Agua file: 023-01.340

November 22, 2016

**RE: Banks Crescent – Proposed 346 Unit Development
Preliminary Engineering Review – Water Supply Requirements**

Figure 1.2 - Existing Local Water Mains

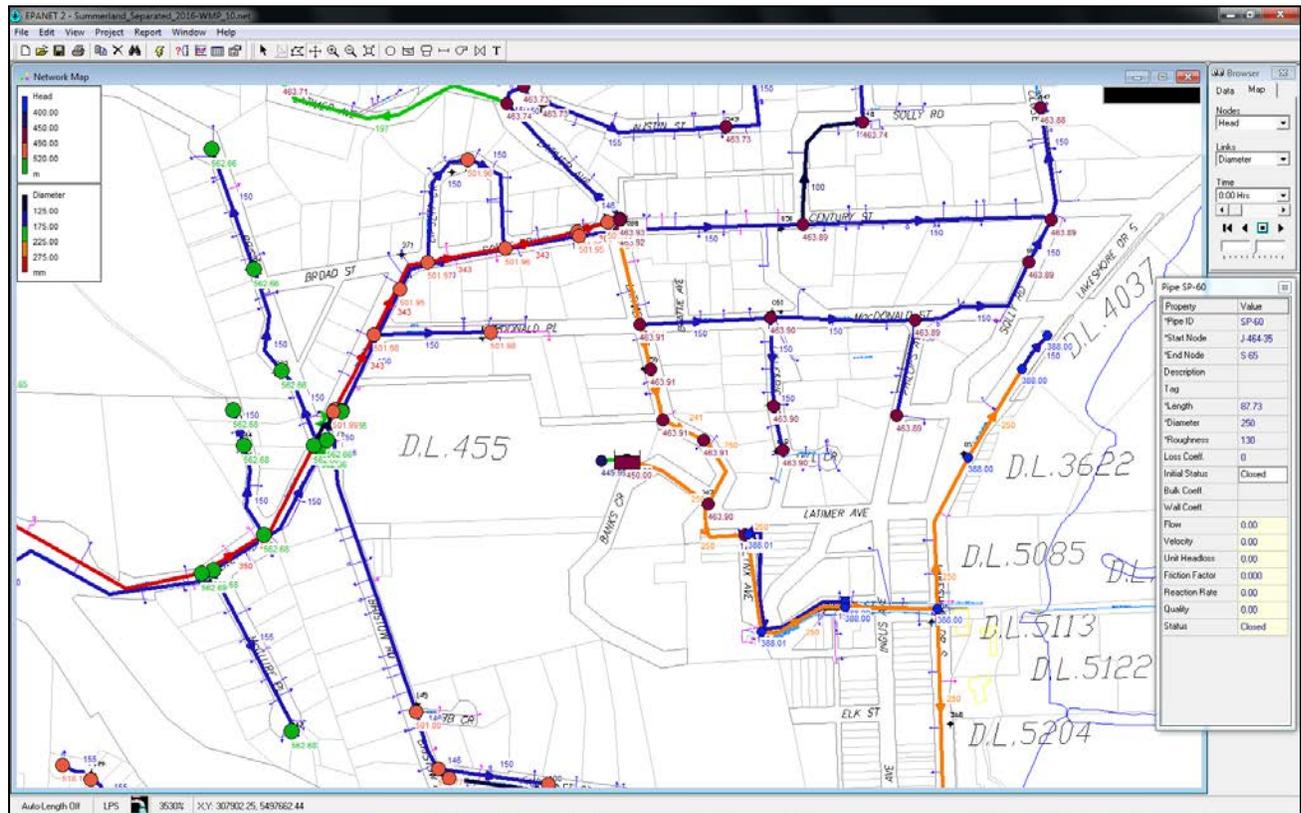
Figure 1.2 presents the existing hydraulic grade lines (HGL) for off-site water mains near the development site. There are three pressure zones in the vicinity of the site, PZ 563 (green nodes), PZ 501 (orange nodes) and PZ 463 (brown nodes). All zone identifications are based on the hydraulic grade line of the water system under maximum day water demand. The pressure zones all feed down from the Summerland Water Treatment Plant which has an operating HGL of approximately 586 metres.

PRV 8, which is a 200mm valve with 75mm low flow valve, exists on Solly Road that connects PZ 563 to PZ 501. Maximum daily flows through PRV 8 are estimated to be in the range of 50 L/s.

PRV 7, which is a 200 valve with 75mm low flow valve, exists on Solly Road at Latimer Avenue and connects PZ 501 to PZ 463. Maximum daily flow rate through PRV 7 is estimated to be in the range of 42 L/s.

Figure 3.1 - Residual HGL and Unit Head loss

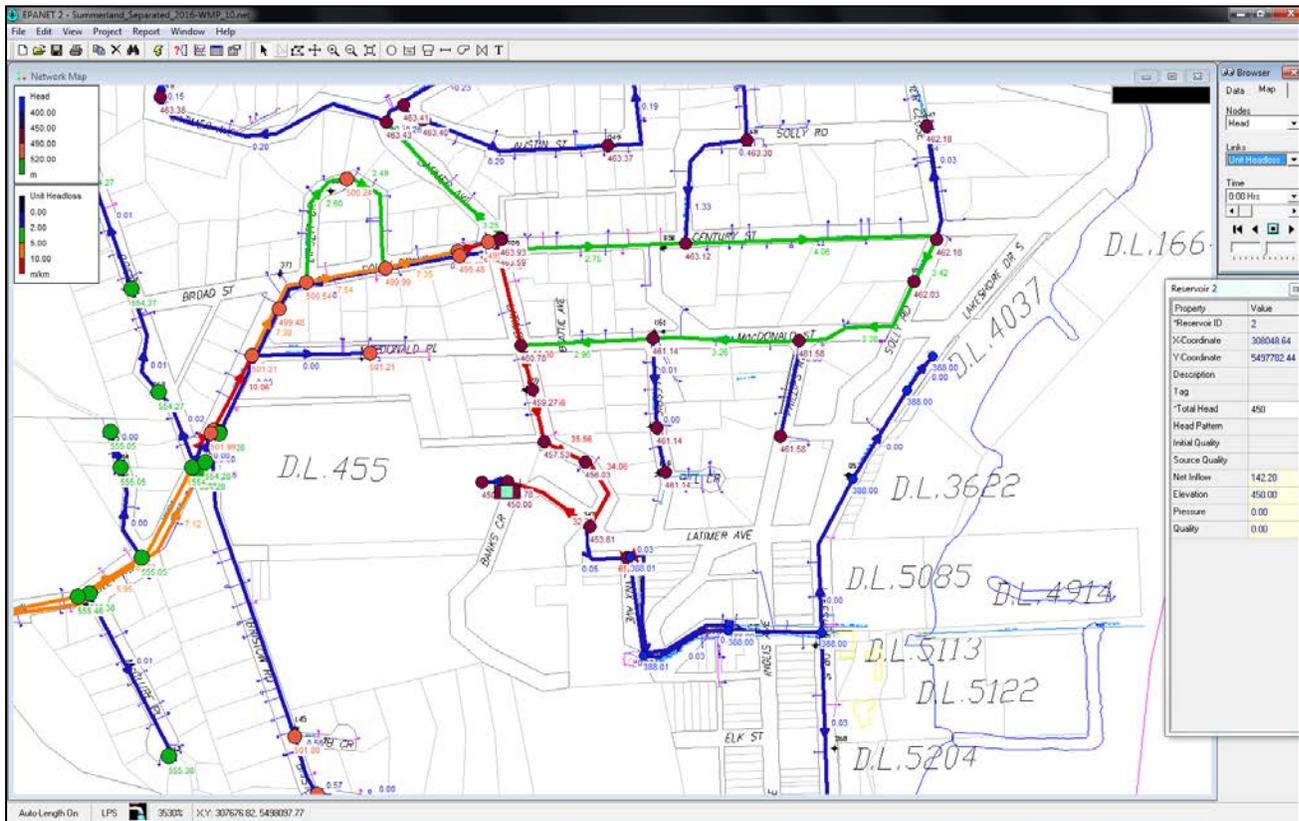
The computer model was tested to determine the available water from PZ 463 (below PRV 7). Another criteria limiting water supply capacity is the 4.0 m/s maximum permissible velocity under fire flow conditions. For a 250mm diameter main this limits flow to 196 L/s. When subtracting the MDD for irrigation and domestic demands, this is further reduced by 11 L/s to 185 L/s available for fire flow.

As modelled, there is 140 L/s available at the site with sufficient residual pressures. Subtract the 11.3 L/s for irrigation and domestic demands, there is only 128.7 L/s fire flow capacity to the site with a residual HGL of 450 m. A residual hydraulic grade line of 450 metres is insufficient to get sufficient water pressure to the upper building floor fire sprinklers.

With the highest floor at elevation 425 metres, a residual HGL of 472 metres is desired to get sufficient pressures to the sprinkler system. There are options for the developer to consider for the sprinkler system including an in-building fire pump system with emergency generator or connect to a higher pressure zone.

Results of pressure drawdown versus flow from the Summerland mains in PZ 463 is presented in Figure 3.1 and summarized in Table 3.1.

- Two options were reviewed for providing water service to the development. The lower capacity water supply option via Latimer Road is presented in Figure 3.1 and Table 3.1. Capacity is constrained by the flow through PRV 8 and PRV 7 and then through the 250mm main to the site;

Figure 3.2 – Available HGL at Development Site

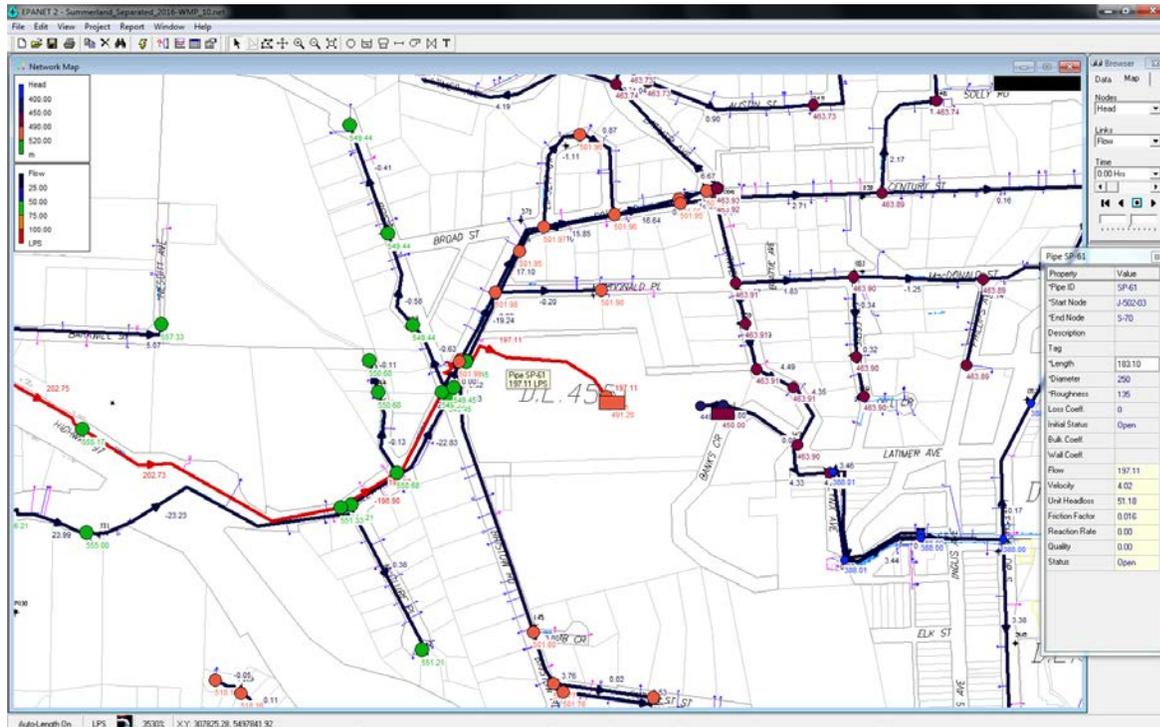
Supplying water to the site from Solly Road is viable as the main size and hydraulic grade line is sufficient to provide water to the highest floors of the proposed buildings, i.e. the fire protection sprinkler system. With a HGL at 502 meters elevation, a 180m length of 250mm diameter water main would be required to get the water from Solly Road, down the steep bank to the development site.

Based on a maximum pipe velocity of 4.0 m/s, if a 250mm diameter main is used, then a maximum fire flow of 185 L/s can be provided. If a 300 mm diameter main is used, then based on velocity, a theoretical maximum flow of 270 L/s can be provided to the site, however this flow is limited by fire storage capacity to 225 L/s.

Results of pressure drop versus flow for this option is presented in Figure 3.2 and summarized in Table 3.2.

If a 300 mm diameter main were utilized, the 4.0 m/s velocity criteria would not be exceeded until the flows were at 280 L/s. To be consistent with the 2008 Water Master Plan, it was identified that the maximum fire flow available to the downtown core was 225 L/s for a duration of 2.875 hours. The fire flow to this site cannot exceed that rate and duration of flow. As a precaution, Summerland staff have checked and confirmed that there is typically more than 2328 m³ of water storage in the WTP clear well during normal operations.

- The higher capacity option for supplying water is to access the 350mm main on Solly Road directly west of the development site. A water main installation would be required off of Solly Road down the steep slope to the site with either a 250 or 300mm main being required. Joint restrained pipe or fused HDPE pipe is required on the silt slope to reduce the chance of pipe failure and/or a significant wash-out. The route for this option is presented in Figure 3.2. Flow data is presented in Table 3.2;

- The recommendation of Agua is to develop a connection to the site from Solly Road from just below PRV 8. PRV 8 would require reconstruction to a larger valve size that would service the development fire flow plus an existing MDD flow below PRV 8 of 50 L/s. From the PRV a joint restrained for fused line is recommended down the steep silt slope to the development area.
